LOT 31, BLK 17, TR 1, U3
PLAN PREPARED BY:
BERNARD R. FREEMAN, PE
FOR
GARY SINGER

APPROVED GRADING AND DRAINAGE PLAN - 2002

LOT 31 BLK 17 TR 1 U 3
PLAN PREPARED BY:
BERNARD R. FREEMAN, PE
FOR
DAN & CHERYL SHELL

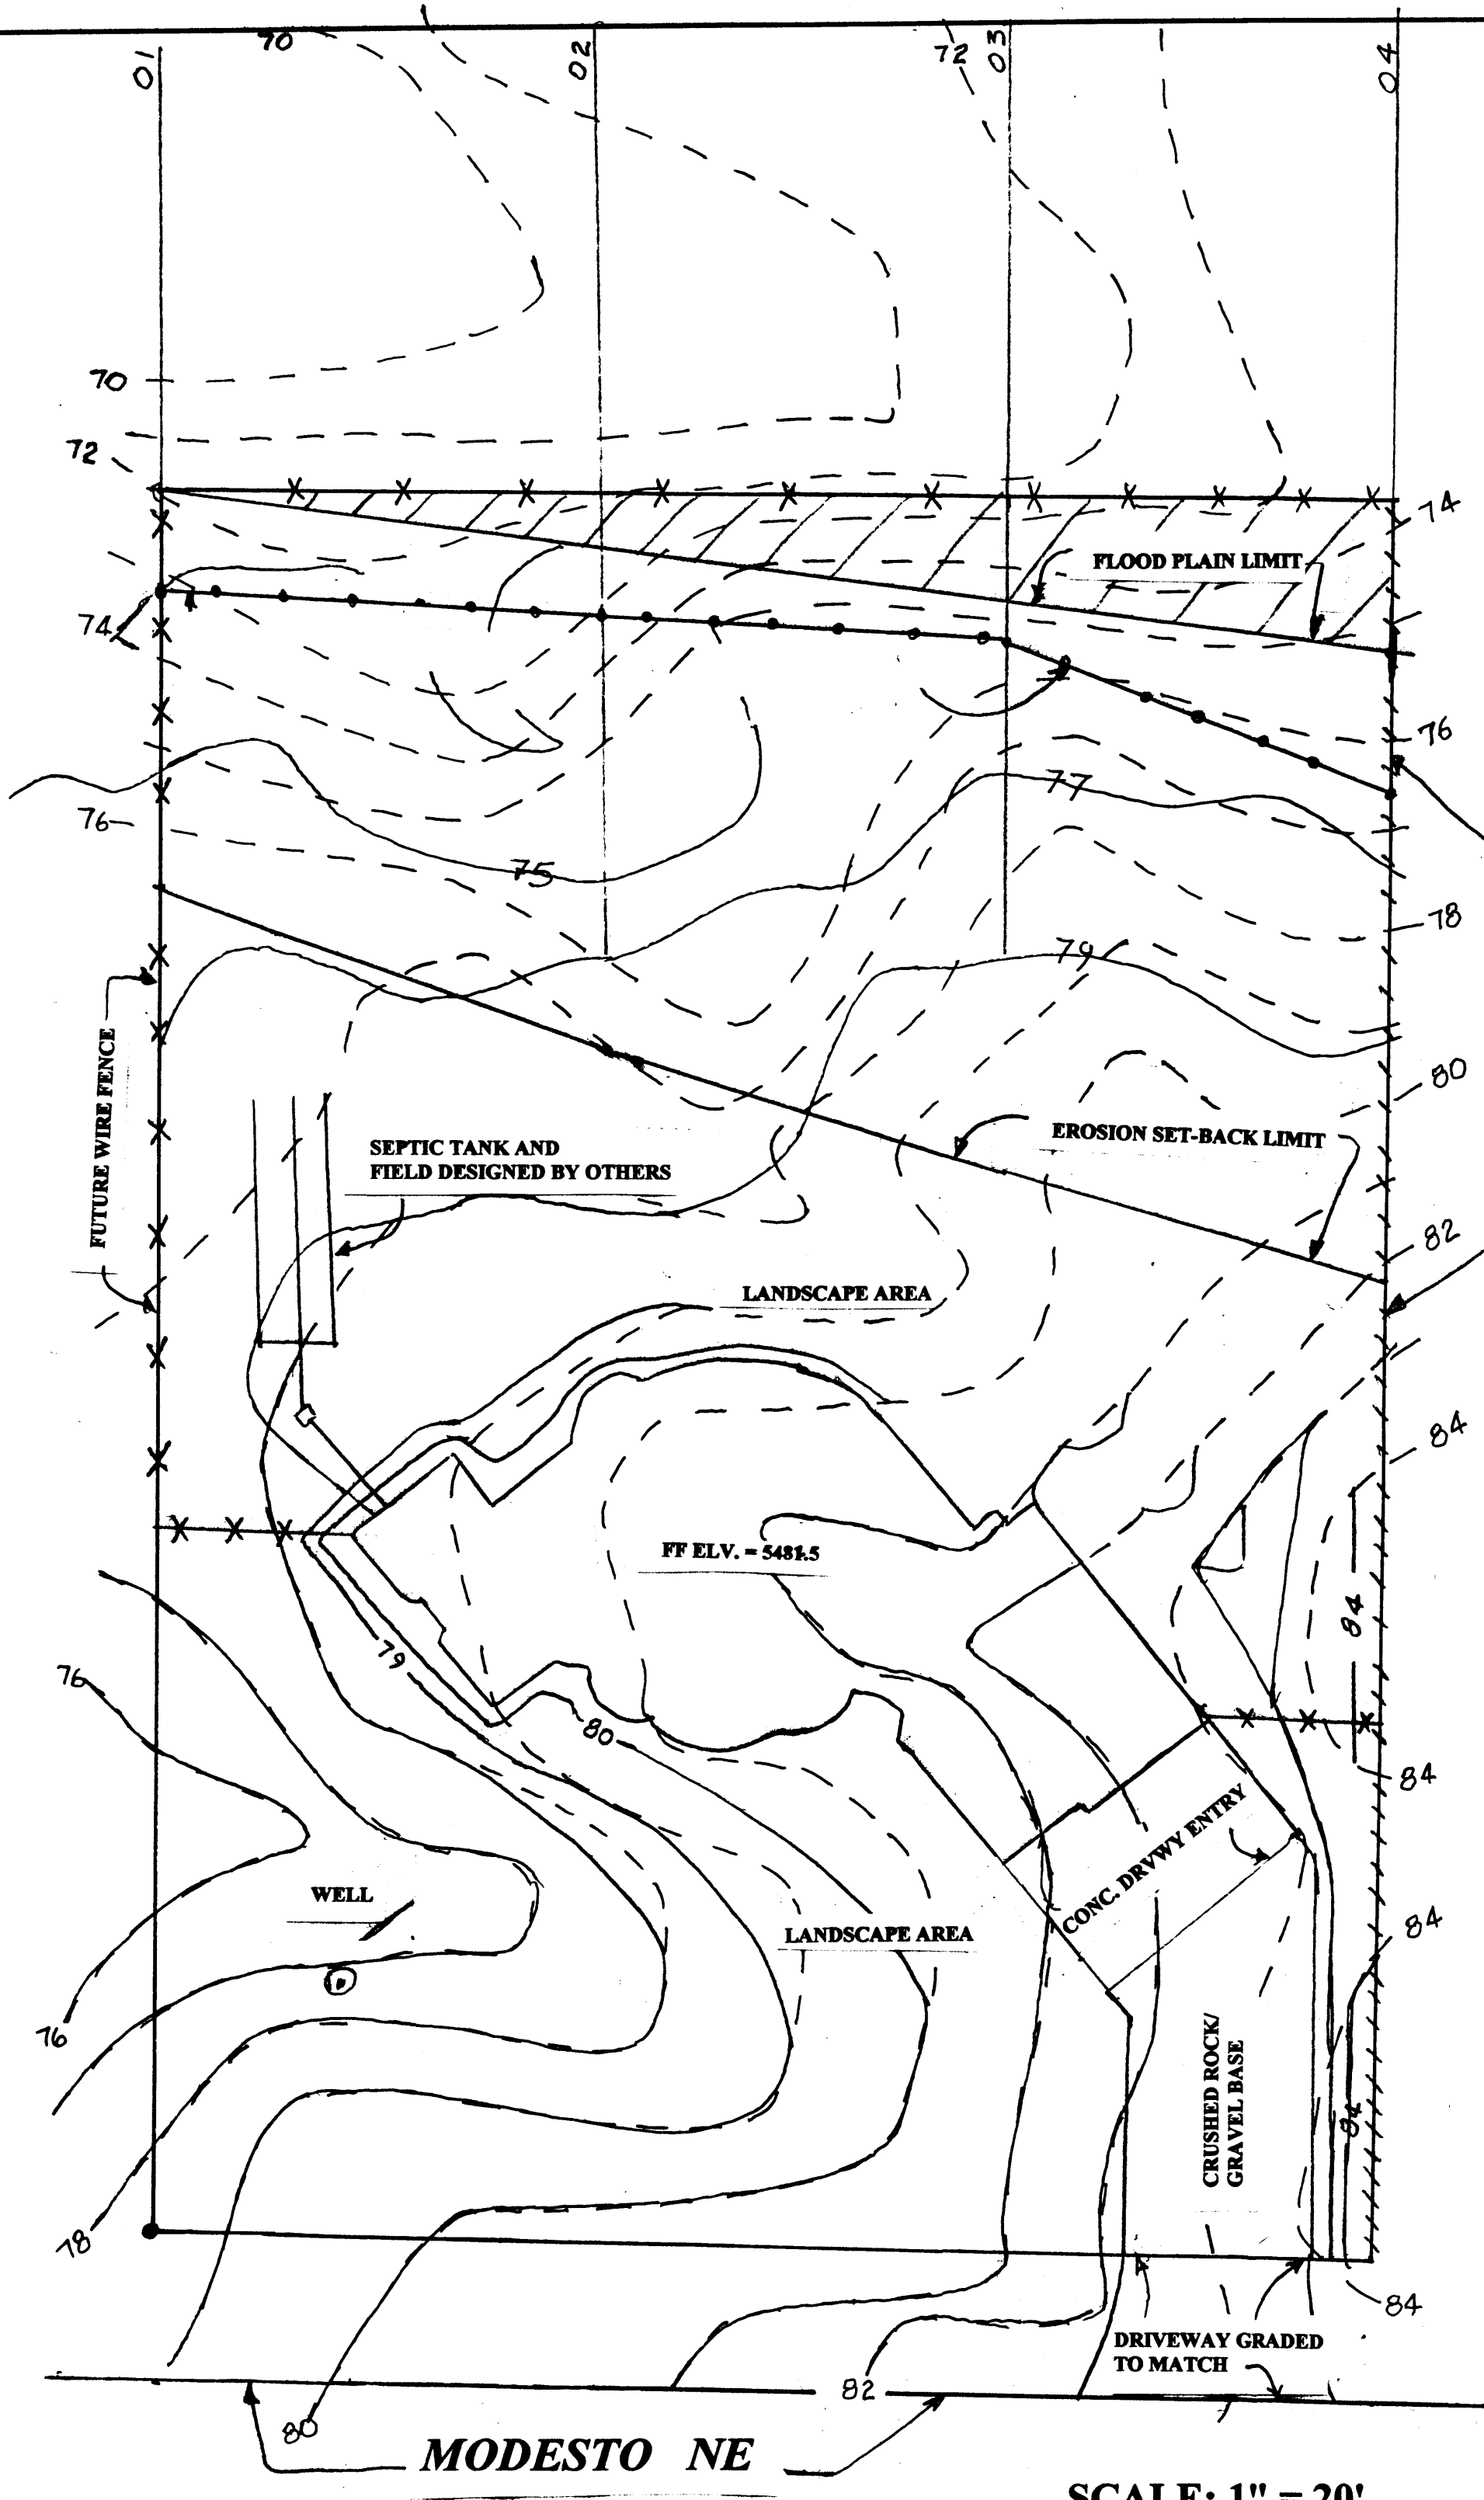
- ① NARRATIVE
- ② ROOF FLOW DIRECTIONS?
X-LOT DRAINAGE
- ③ DEAL W/ Q ON WEST SIDE
OF LOT
- ④ WALKS?
- ⑤ FIRM MAP?
- ⑥ CALL OUT SPECIFIC
WORK TO REMOVE FLOOD PLAIN
